175	02/23/11	CO #147
458	02/27/12	CO #337
458	03/16/12	ASI #190

ADDITIONAL NOTES FOR INSTALLATION OF METAL SUSPENSION CEILING SYSTEM PER OSHPD RESOLUTION TO COMPLY WITH CBC SECTION 1614A.1.1 AND 809.1.

A11.10.2

COMPLY WITH CBC 2007 SECTIONS 1614A.1, 9803.9.1.1 & 2506.2.1, ACSE07 SECTION 13 & IR 25-5 REQUIREMENTS FOR SUSPENDED CEILINGS.

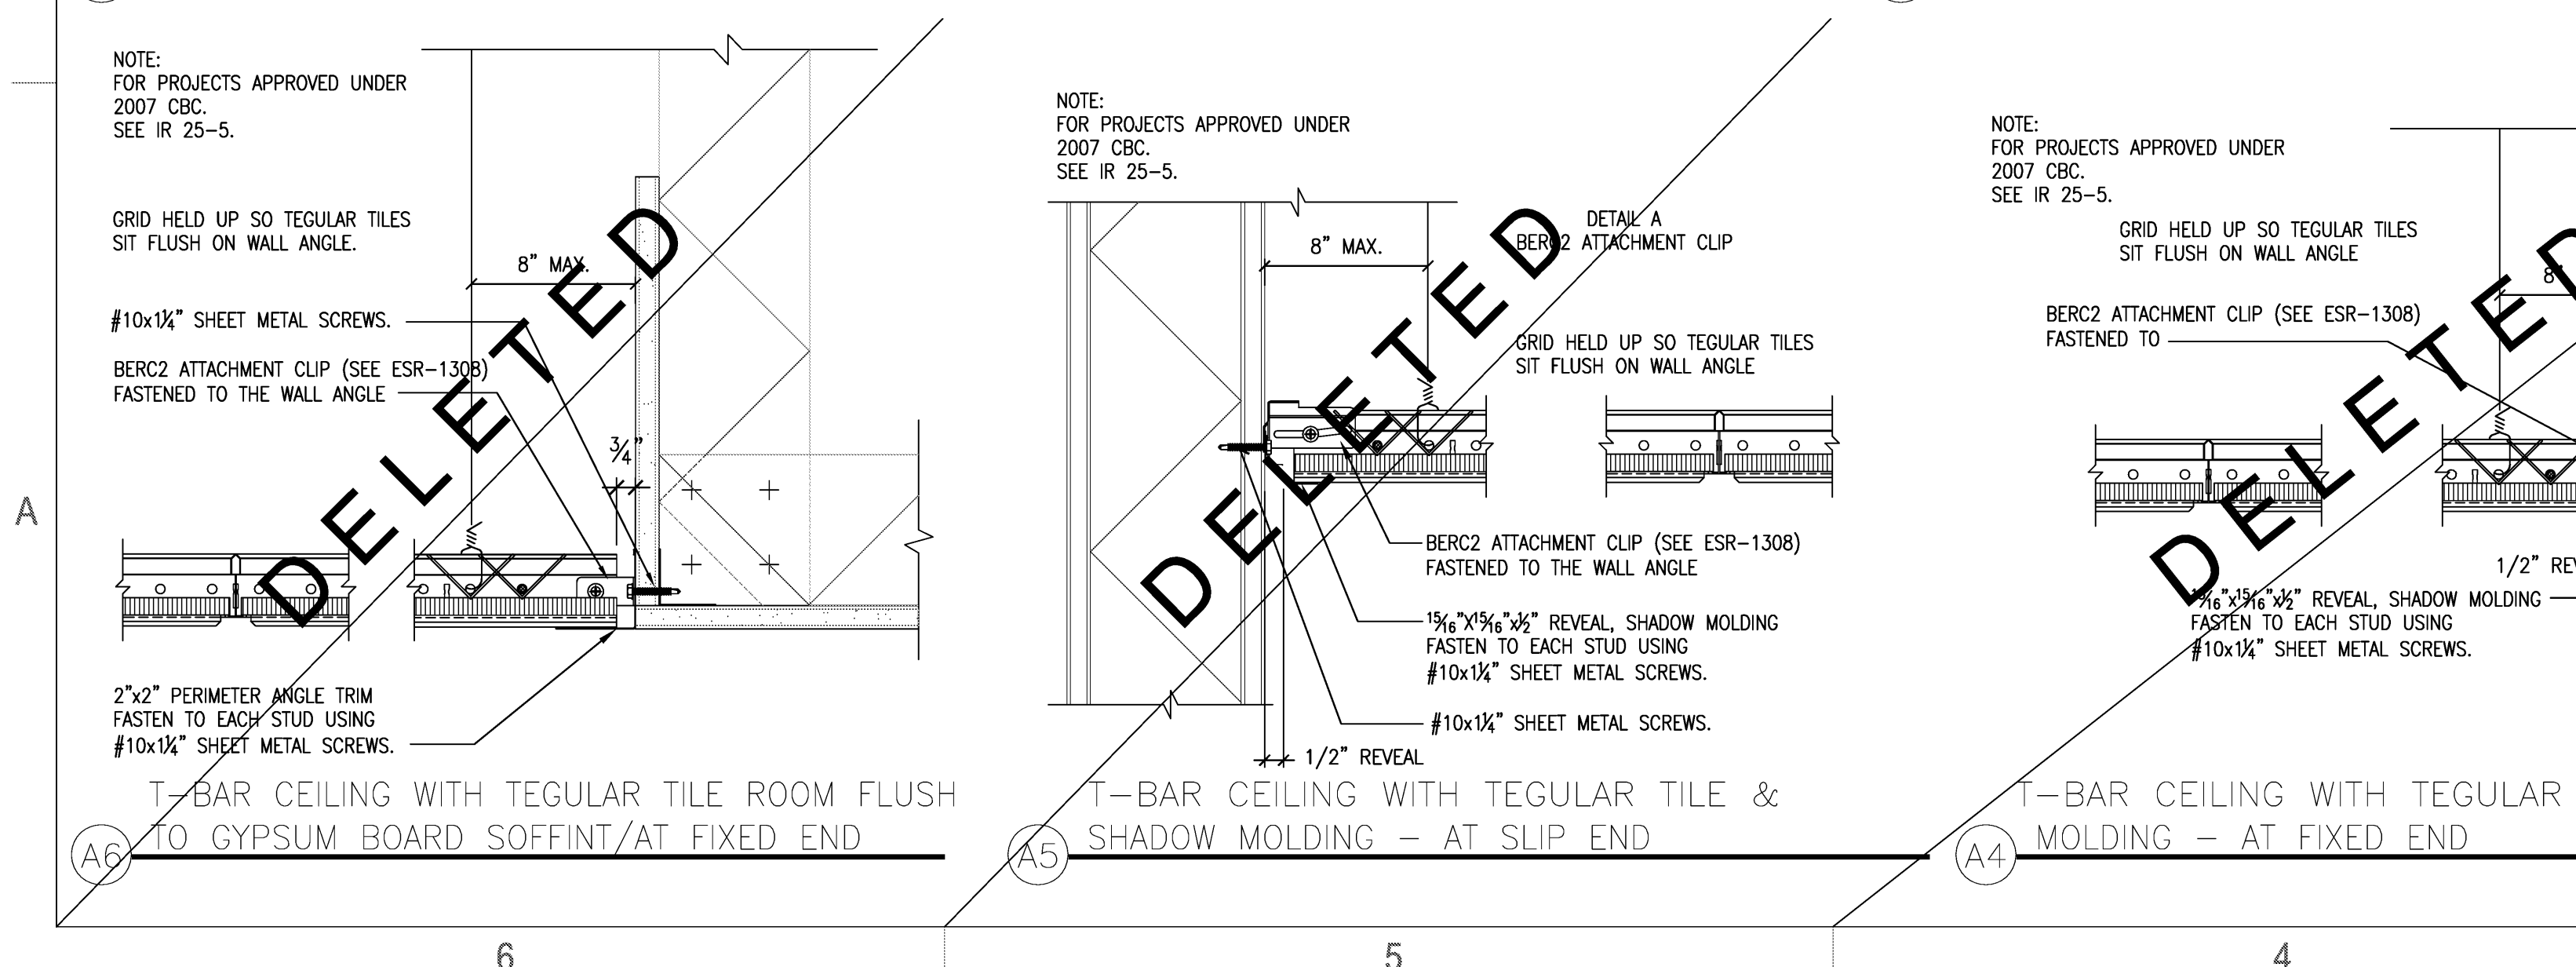
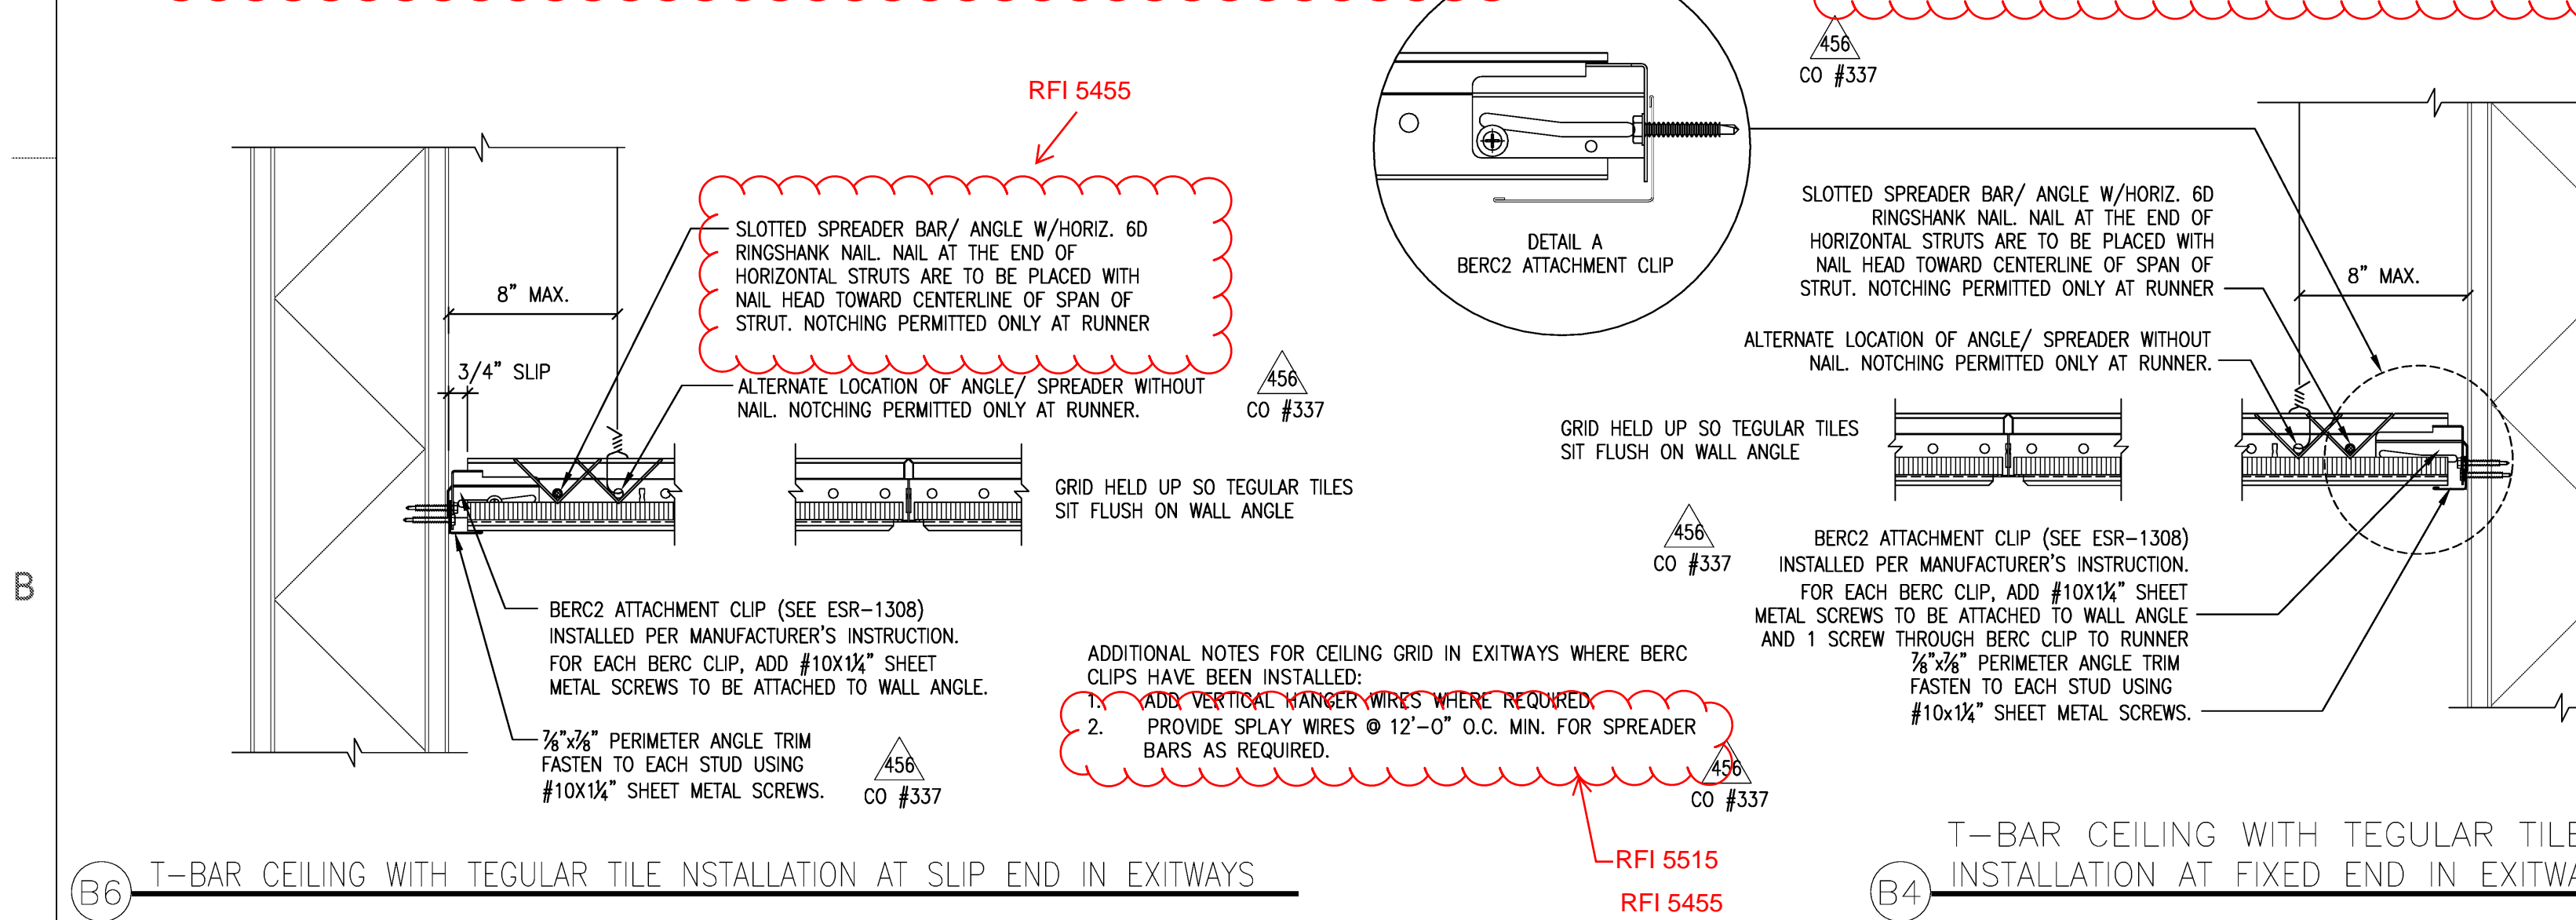
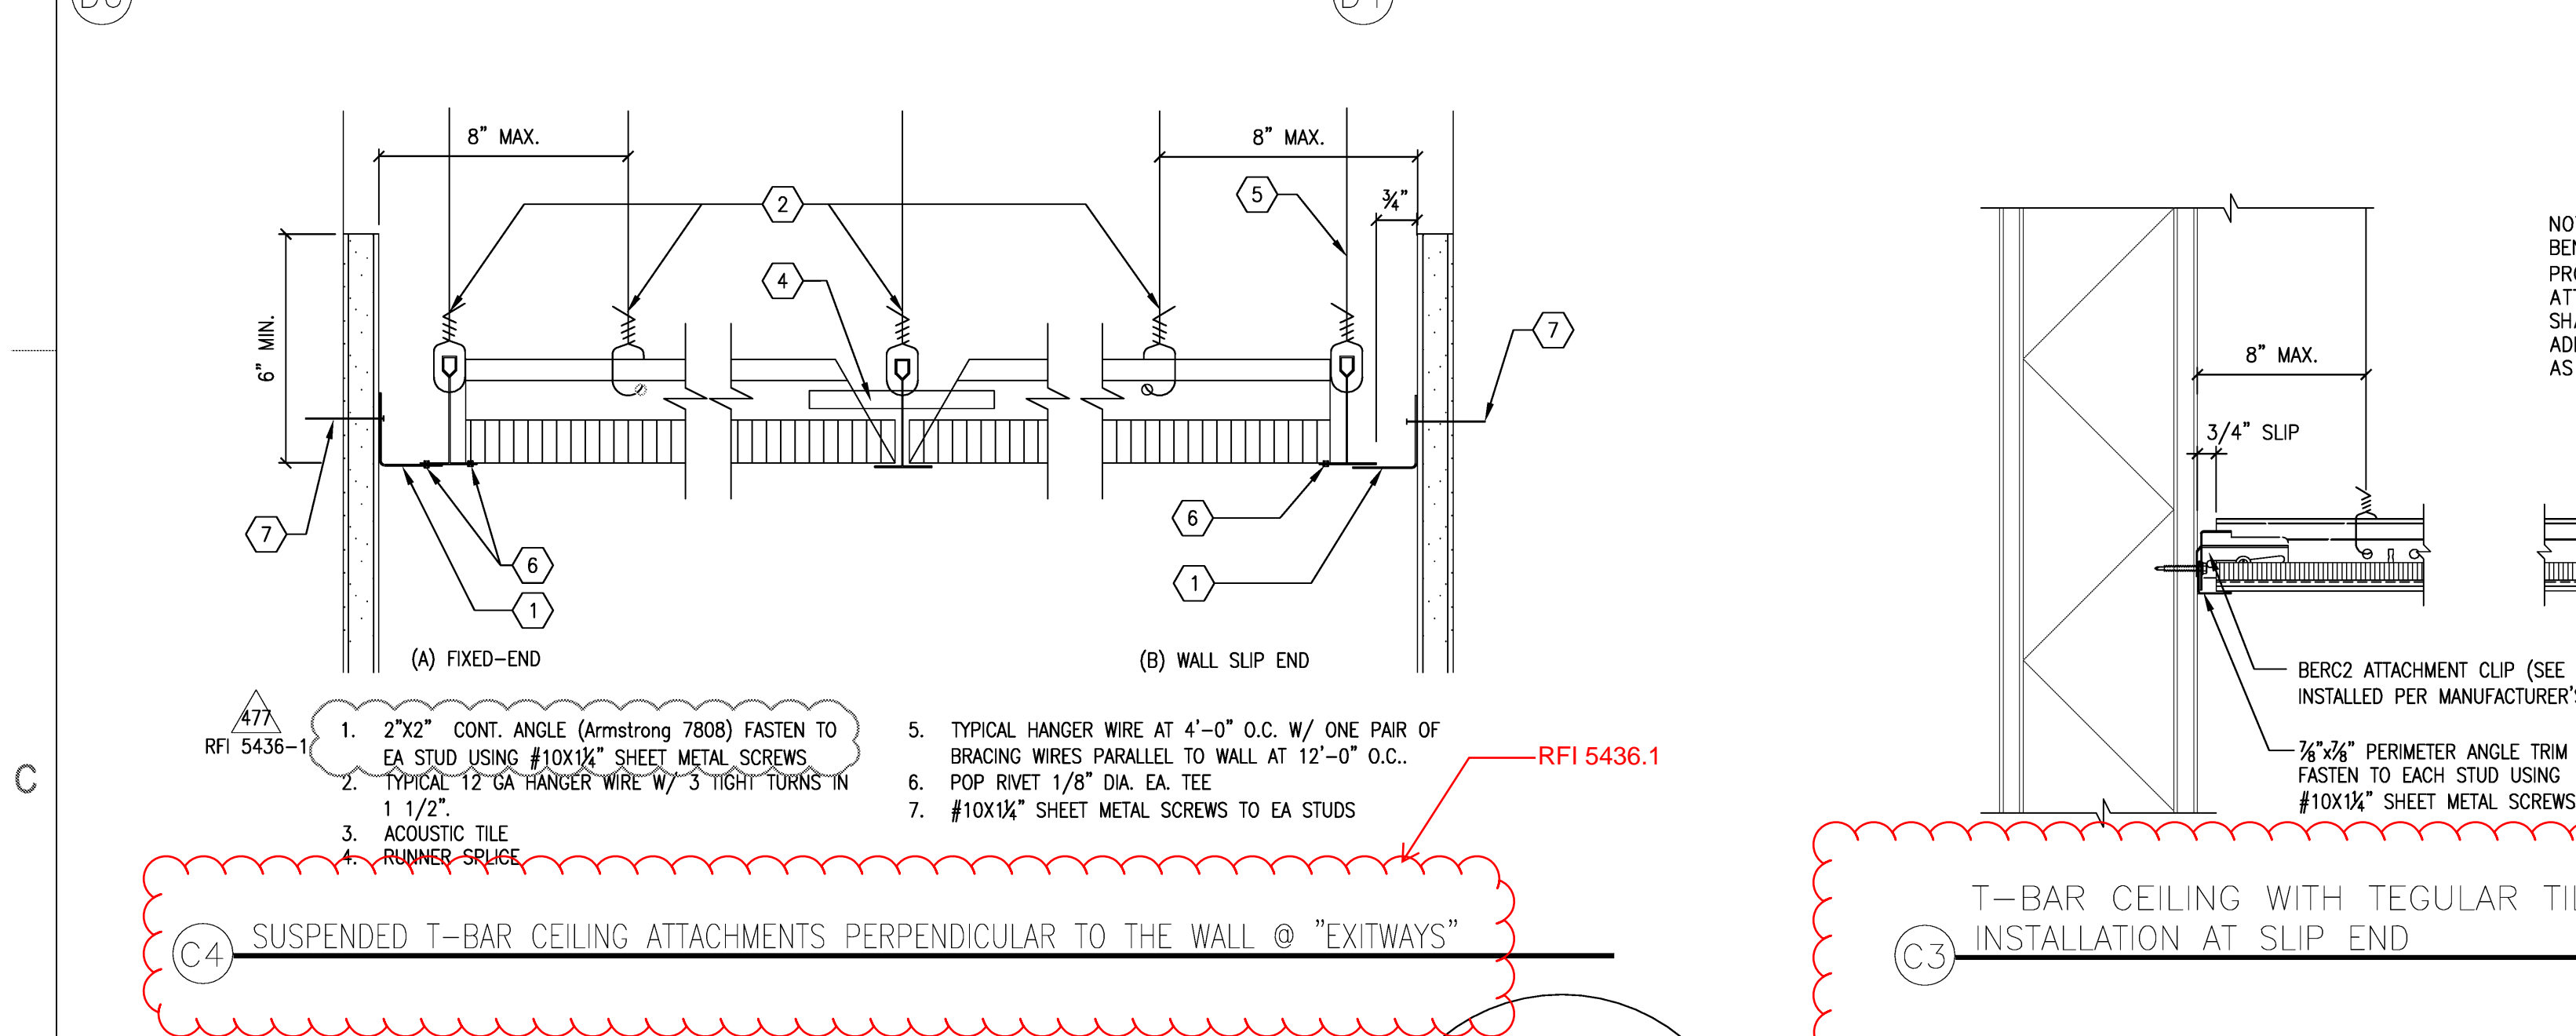
- WHERE CEILING GRID HAS NOT YET BEEN INSTALLED IN EXITWAYS:
 - USE DETAIL C4/A11.10.2
- FOR CEILING GRID IN EXITWAYS WHERE BERC CLIPS HAVE BEEN INSTALLED:
 - USE DETAIL B4 & B6/A11.10.2
 - VERTICAL HANGER WIRES WILL BE ADDED TO THE RUNNERS PERPENDICULAR TO THE WALL ANGLE FOR BOTH FIXED AND SLIP END AS REQUIRED ON A CASE-BY-CASE BASIS VERIFIED BY THE IOR, SEOR AND AOR.
